Service Sheets for the **Norton** **Commando**

Reproduced from original Norton material
with permission of the Norton copyright holders
by

SERVICE RELEASE

NO. N6.

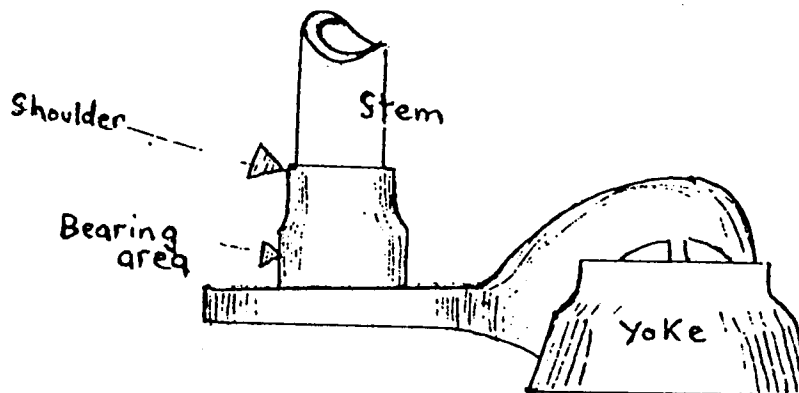
EXPLANATION: During assembly of the fork lower lug and stem to the steering head tube of the frame, it is possible for the shoulder of the stem to become lodged against the lower headrace. If this is not realised and the fork should turn on to full lock, the thick cross section of the yoke will lodge against the lock stop on the frame. As the stem is drawn home into the bearings by tightening of the large stem nut, the yoke cannot follow and will either be distorted beyond further use or fractured in the area where the stem joins the yoke.

ACTION: To prevent damage, ensure that the correct lower portion of the stem is central in relation to the lower bearing inner race before the stem nut is tightened.

NO. N7.

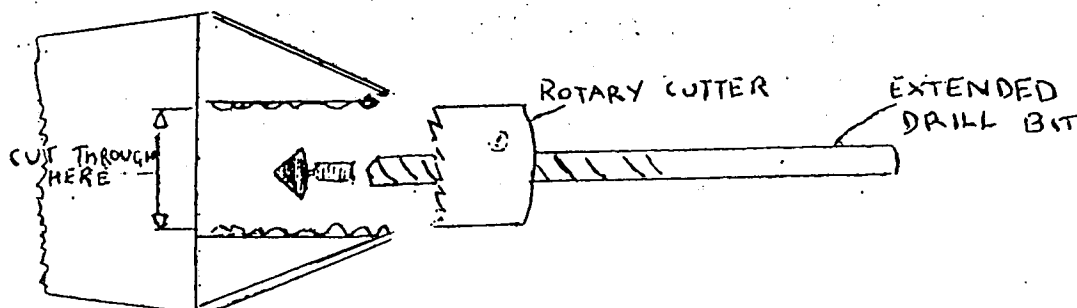
EXPLANATION: We are advised of sales resistance to machines fitted with the latest reverse cone silencers with perforated tubes in the end cones due to a whistling effect over subdued exhaust note.

ACTION: Using a 13/16" diameter sheet metal rotary cutter on an extended drill bit cut a hole through the blanking plate as shown below.

This modification makes it essential to change the main jets to 210 and to drop the needle in the clip to the top (No.1) groove. If carburation is not corrected after this silencer modification, severe damage will be caused. Observe that the resultant exhaust note still falls within legal requirements.

NO: N10.

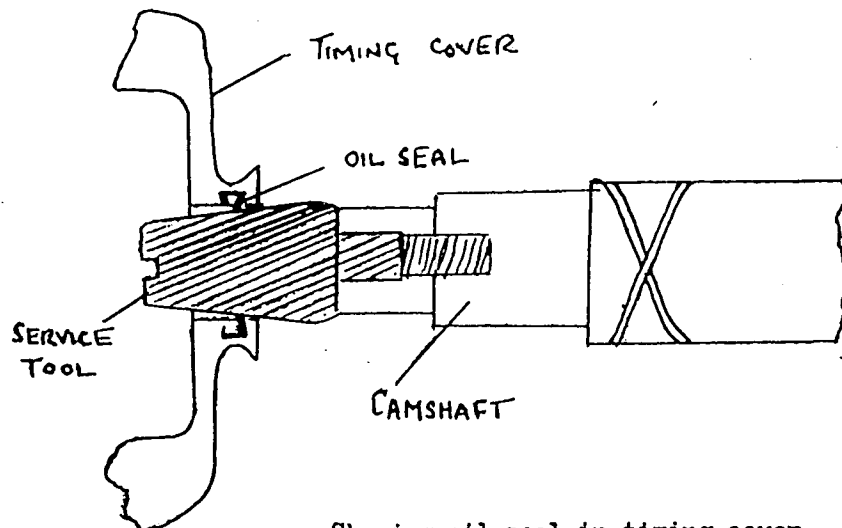
EXPLANATION: When the timing cover is offered over the end of the camshaft, the oil seal at the contact breaker housing must pass over the large diameter of the camshaft. This invariably causes damage to the pressure lip of the seal. A special tool is provided in the tool kit to screw into the end of the camshaft and guide the seal home without damage.

NO: N.12

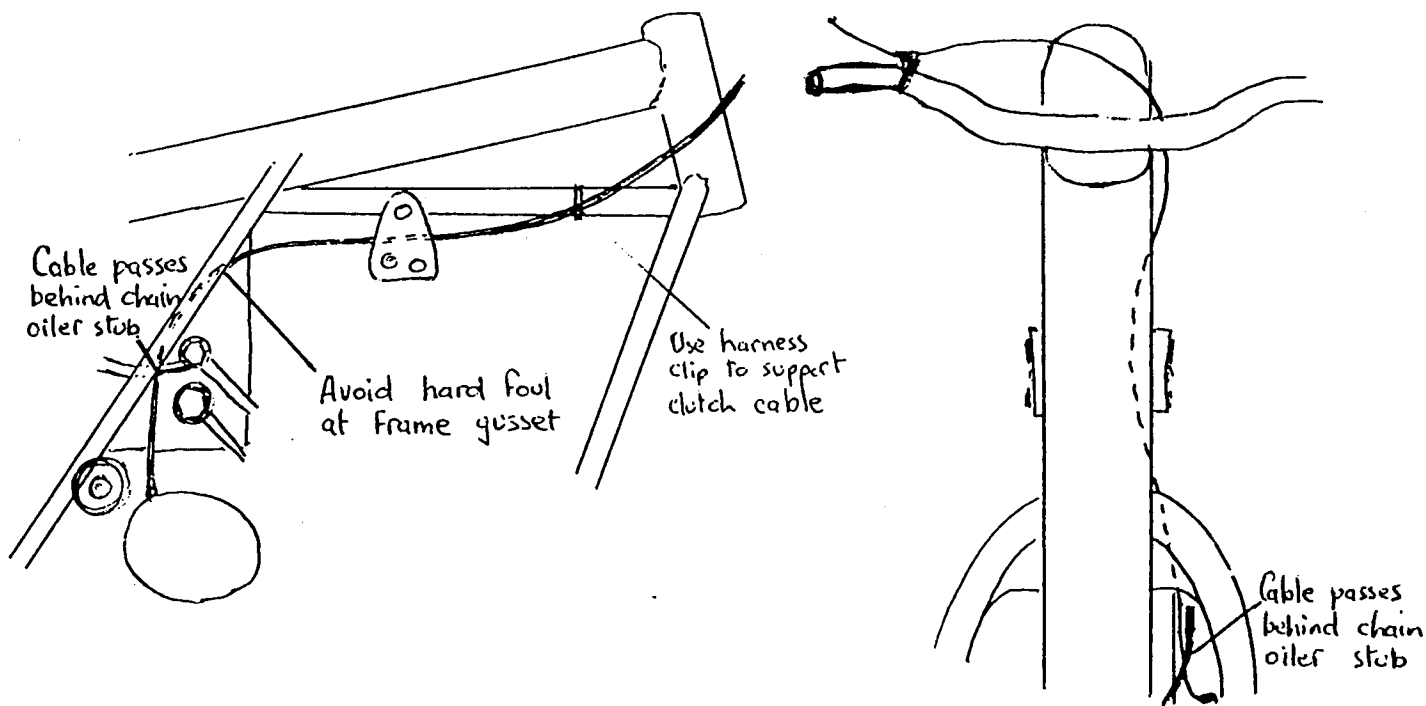
EXPLANATION: Due to incorrect routing of the clutch cable there have been certain complaints of a stiff clutch action. This is not due to any shortcoming in either the clutch or clutch thrust mechanism but is purely attributable to the run of the cable.

NATURE OF RELEASE: Warning light assimulator

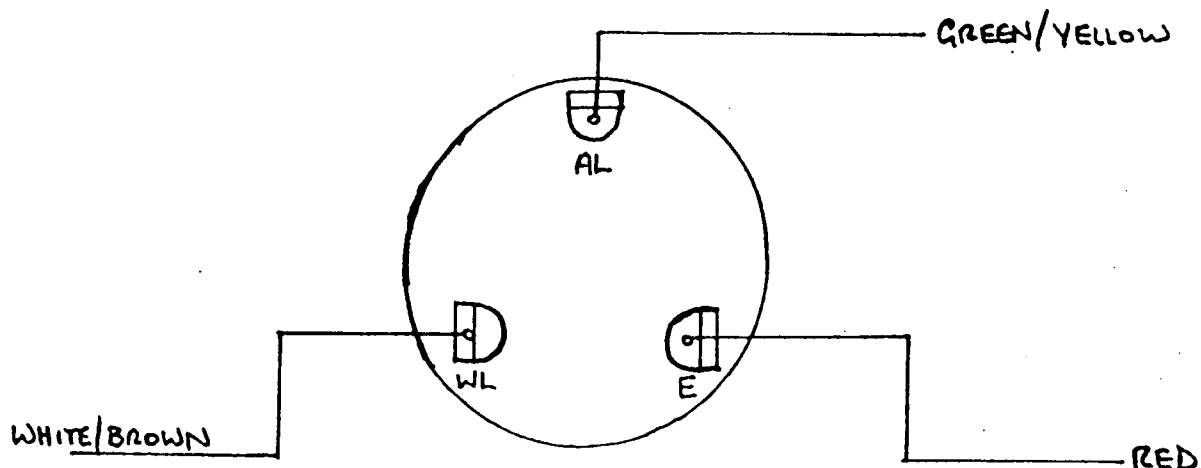
EXPLANATION: Instances have been reported of the charge warning light assimulator, being inoperative ie. the light has remained on when charging has been taking place. Investigation suggests that affected machines have had the leads to the assimulator connected incorrectly.

ACTION: Remove the fuel tank to gain access to the voltage assimulator connections. Ensure that the leads are connected as shown below.

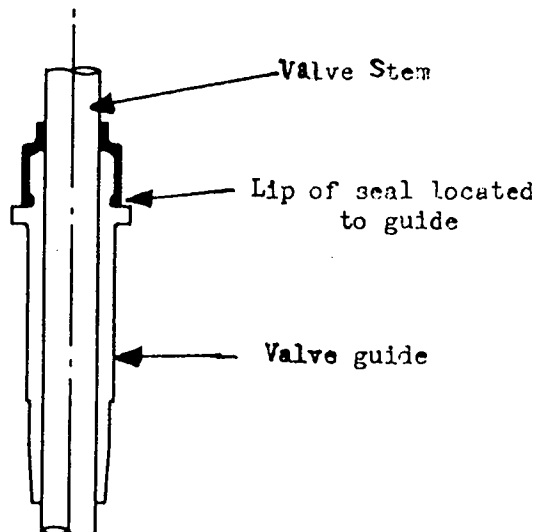
Inlet valve guide seal 062726

Front drum brake - high performance modification.

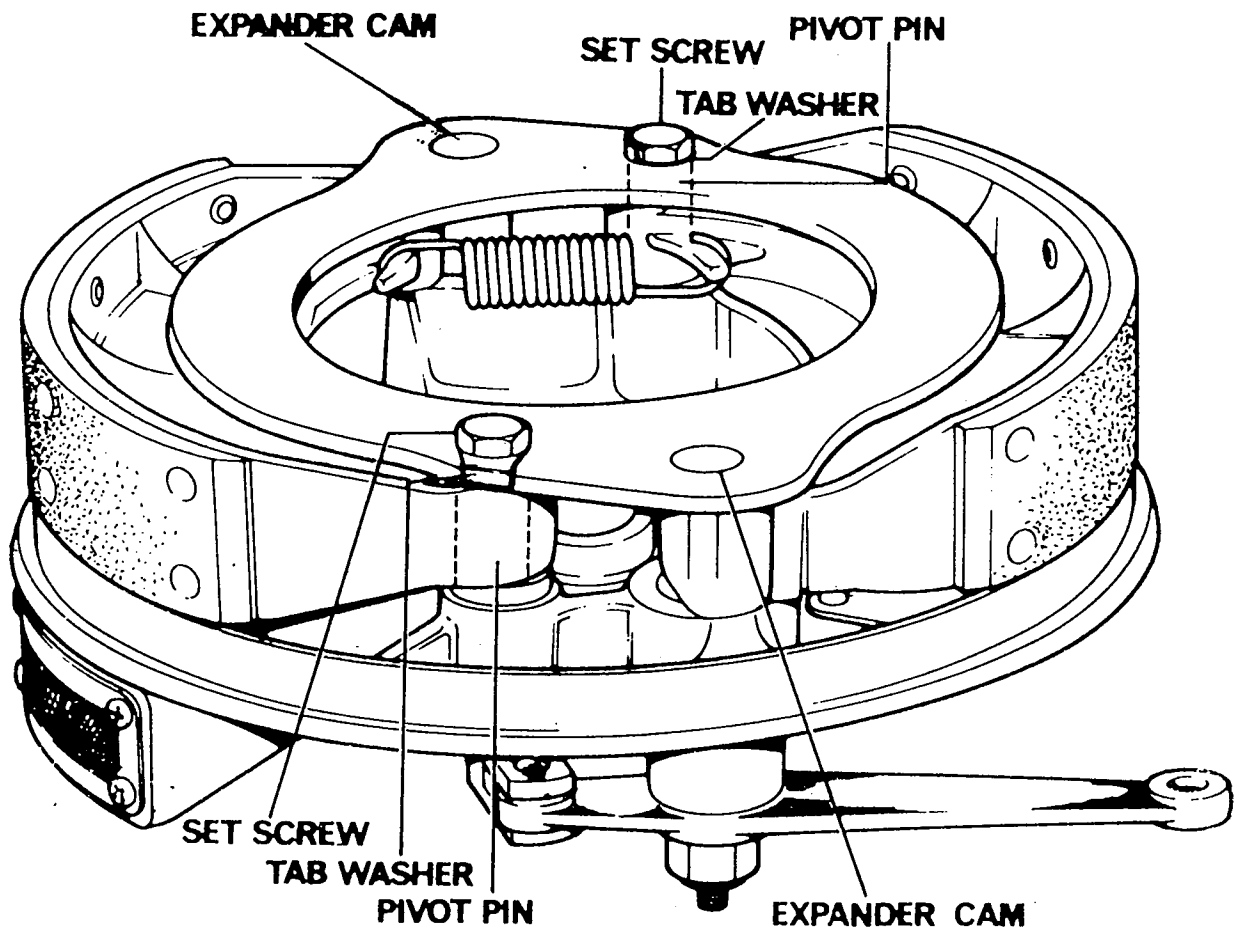
To stiffen up the two leading shoe front brake assembly, thereby providing an appreciable improvement in braking figures for high performance purposes, a support plate is introduced. The support plate ties in a precise relationship between both brake cams and pivot pins. The support plate is shown in the illustration, in situ. The parts required to convert an existing brake are available in kit, Part No.063410, comprising:-

To convert an existing brake plate, remove the brake shoes and springs, the brake expander cams and both pivot pins. To remove the short pivot pin, first support the brake plate firmly and squarely under a drilling machine and gently remove the rivetted shoulder of the fixed pivot pin. Final detachment of the stop pin may necessitate heating the brake plate by immersing in boiling water before driving or pressing out. Retain the chamfered washer. Replace the new pivot pin by pressing into the brake plate pin housing and supporting the brake plate and new pivot pin firmly and squarely, fit the washer over the pivot pin, chamfer facing outwards. It is most important to rivet the short pin,

securely and neatly in position in the brake plate. Replace the second new threaded pivot pin and nut and expander cams. Reassemble the brake shoes and springs then locate the support plate over the brake cams. Secure the plate with set screws 26484 ($\frac{1}{4}$ in. UNF) and tab washers 060395. Tighten the set screws then tap the tab washers into the position shown in the illustration. The brake is now ready to put back into service.

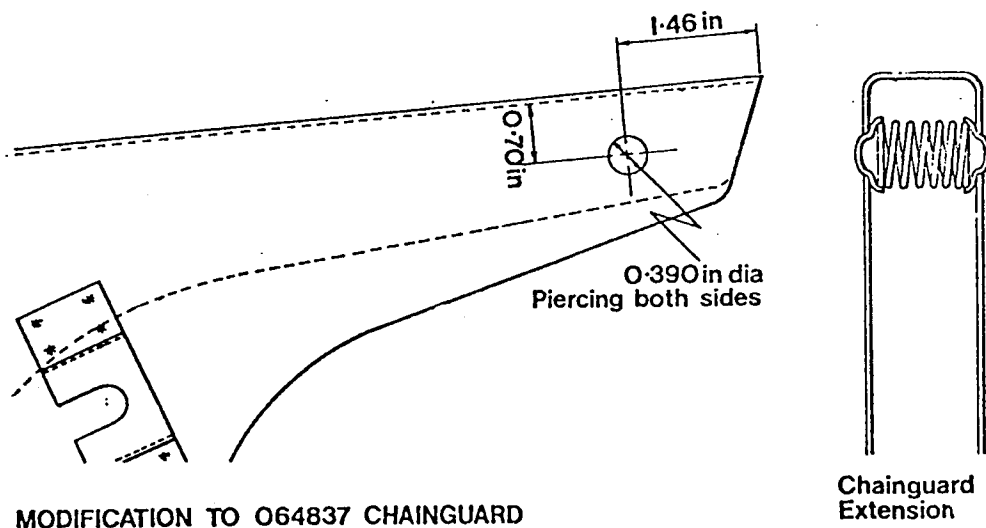
EXPLANATION: A new rear chainguard has been introduced on assembly subsequent to engine number 307091 which incorporates a detachable extension piece.

The new chainguard 064837 is similar to the superseded part 061865 but incorporates two additional pierced holes into which the additional plastic extension piece locates.

FIG. 1. PISTON CROWN MODIFICATION

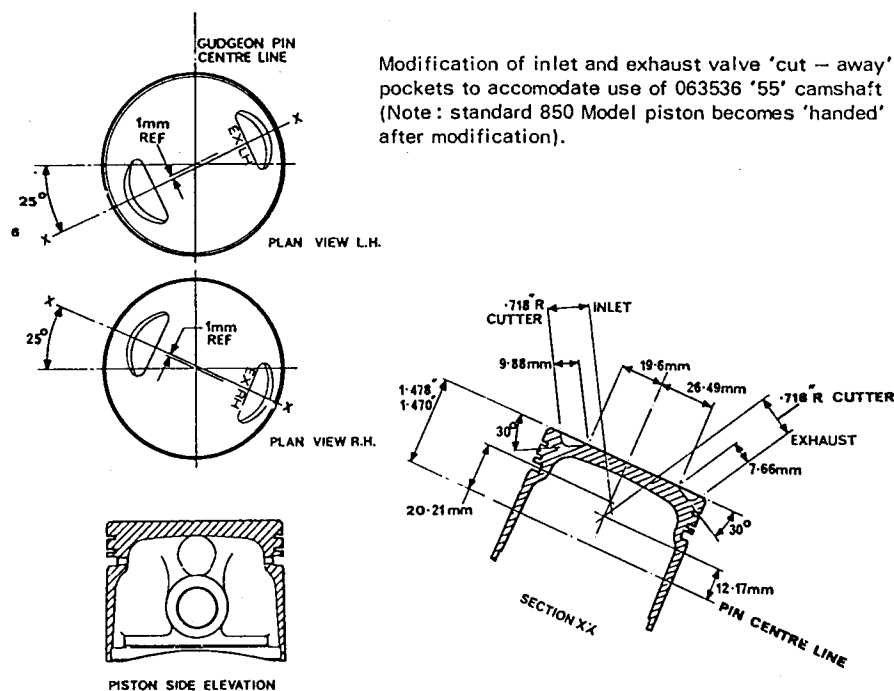
1. Piston Conversion of the standard 850 piston 063838 to sports condition involves deepening the valve 'cut-away' pockets in accordance with the dimensions given in Fig. 1.

The cut-aways require re-machining to the amended conditions as shown to allow for the additional 'valve drop' created by the use of the new Camshaft 063536. The head diameters of both the inlet and exhaust valves should be measured — ensure head diameters do not exceed 1.490 in. (37.85 mm) inlet, and 1.302 in. (33.07 mm) exhaust. This will avoid any possibility of subsequent 'hook up' when using 063536 Camshaft in the higher engine R.P.M., range.

FIG. 2. CYLINDER HEAD MODIFICATION

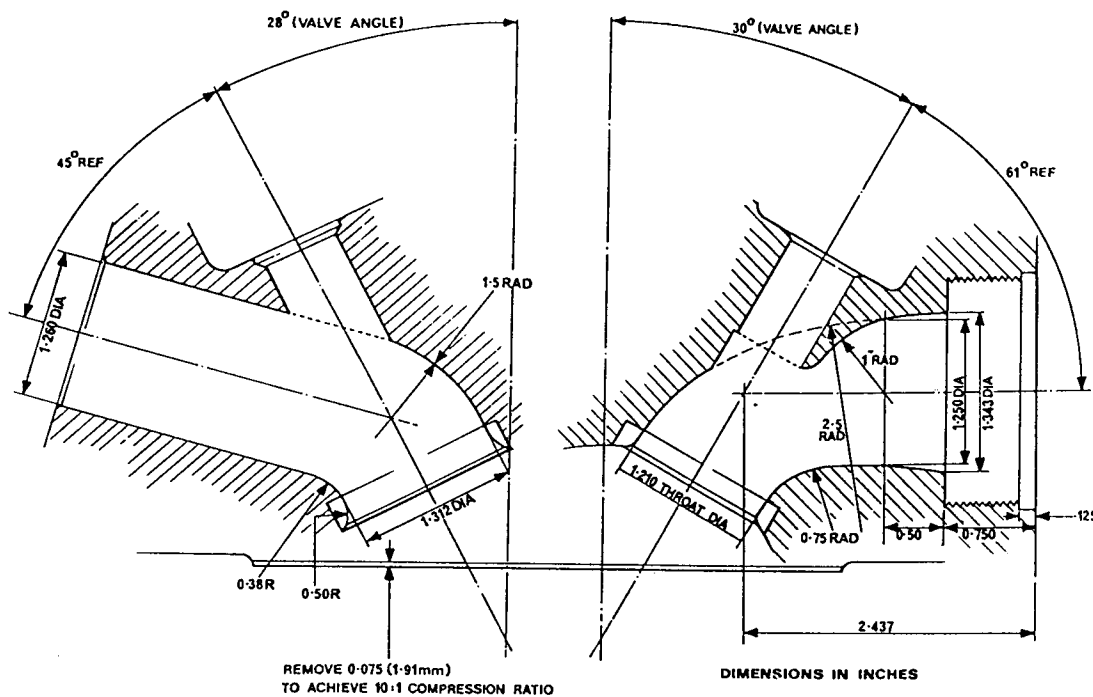
The diagram (Fig. 2) details the modifications that are recommended to increase the compression ratio to 10:1, and to convert both inlet and exhaust ports to the recommended shape to provide optimum power with flexibility.

FIG.3 PUSH ROD MODIFICATION

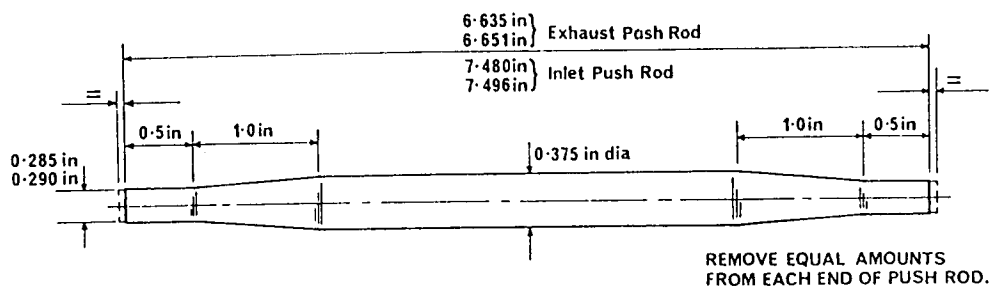
In order to maintain correct rocker geometry following removal of material from the cylinder head gasket face it is recommended that both end caps are removed from each of the four push rods, and 0.037 in (0.95mm) of metal removed from each end of the push rod prior to replacement of the end caps. Do not remove all the metal from one end only of the push rod as this may result in the end caps not re-seating properly, and only partially resting onto the taper run-out of the push-rod itself (see Fig. 4.).

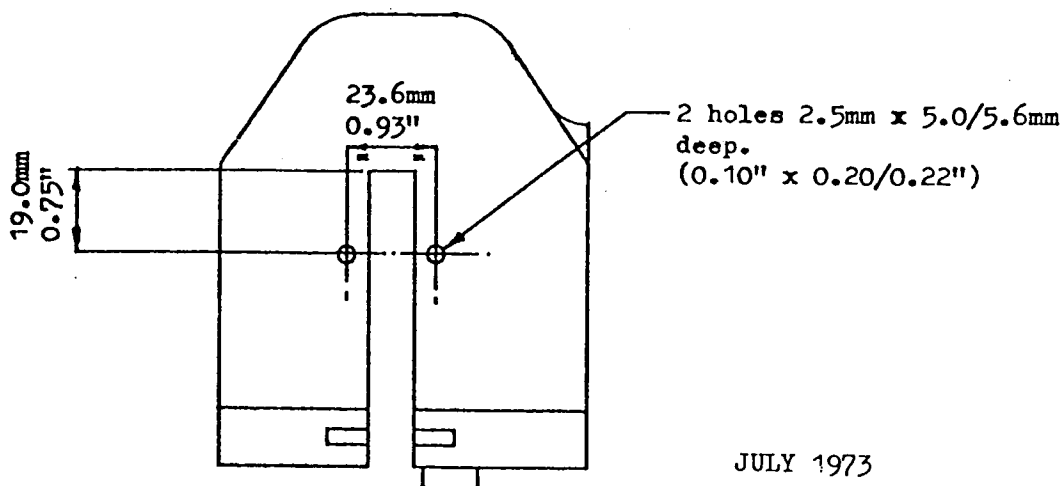
The scraper is designed to prevent dust and abrasive particles entering the caliper yoke and initiating abrasive wear of the disc and friction lining pads.

065173 Caliper assembly incorporating disc scraper
